URGENT FIELD SAFETY NOTICE**Manufacturer SRN:** DE-MF-000020091**FSCA Reference:** 1427918 - Bubble Sensor - Bad contact in sensor cable**FSN Type:** New**Affected Product:** BS 3/8x3/32 L1.7 Mat. 701055720
(Bubble Sensor for 3/8" x 3/32" tubing, length 1,7 m)**Unique Device Identifier:** 04037691816432**Affected Serial No.:** All serial numbers are potentially affected.**For Attention of:** Users of the medical device listed above

Maquet Cardiopulmonary GmbH (MCP) would like to inform users about a corrective action related to the cable durability of the Venous Bubble Sensor.

Figure 1 Picture of a Venous Bubble Sensor

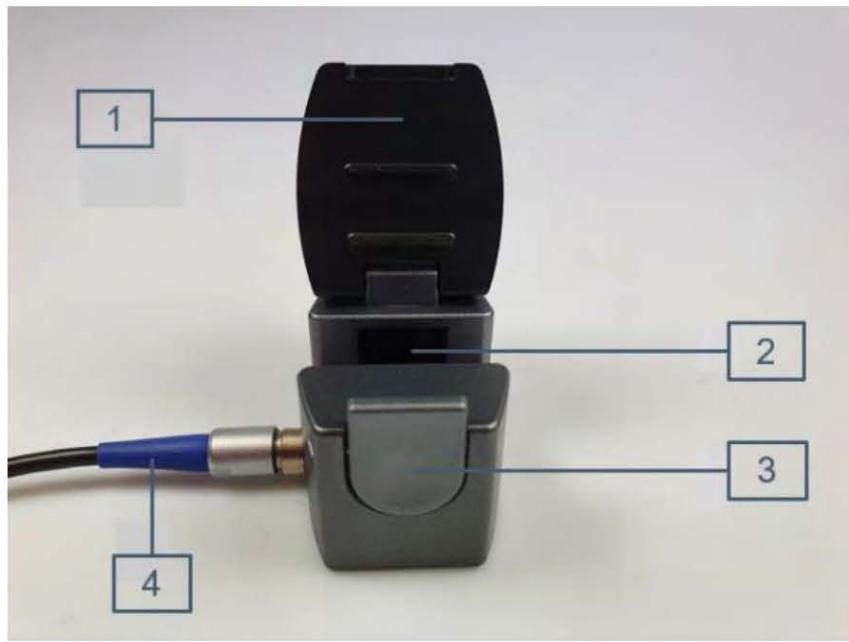
Internal investigations have identified an issue with the durability of the connecting cable (See Fig. 1 position [4]) near the connection to the Bubble Sensor. Excessive bending of the cable can lead to poor contact, which may trigger the errors "Ven. bubble sensor defective" or "Ven. bubble sensor disconnected" on the connected medical device (ROTAFLOW II or CARDIOHELP-i). These errors can occur temporarily when the cable is moved or permanently if the connection is fully compromised.

- **The Venous Bubble Sensor remains functional until error ("Ven. bubble sensor defective" or "Ven. bubble sensor disconnected") displays on the main device.**
- **To prevent error occurrence please follow these guidelines when handling Venous Bubble Sensors:**
 1. **Avoid roll up or coiling of the sensor cable!** When storing affected products, place them loosely in a box or bag to prevent damage.
 2. **Avoid excessive bending** of the Venous Bubble Sensor.
 3. **Handle the Sensor cable with care during cleaning.** Do not pull with excessive force while wiping the cable.
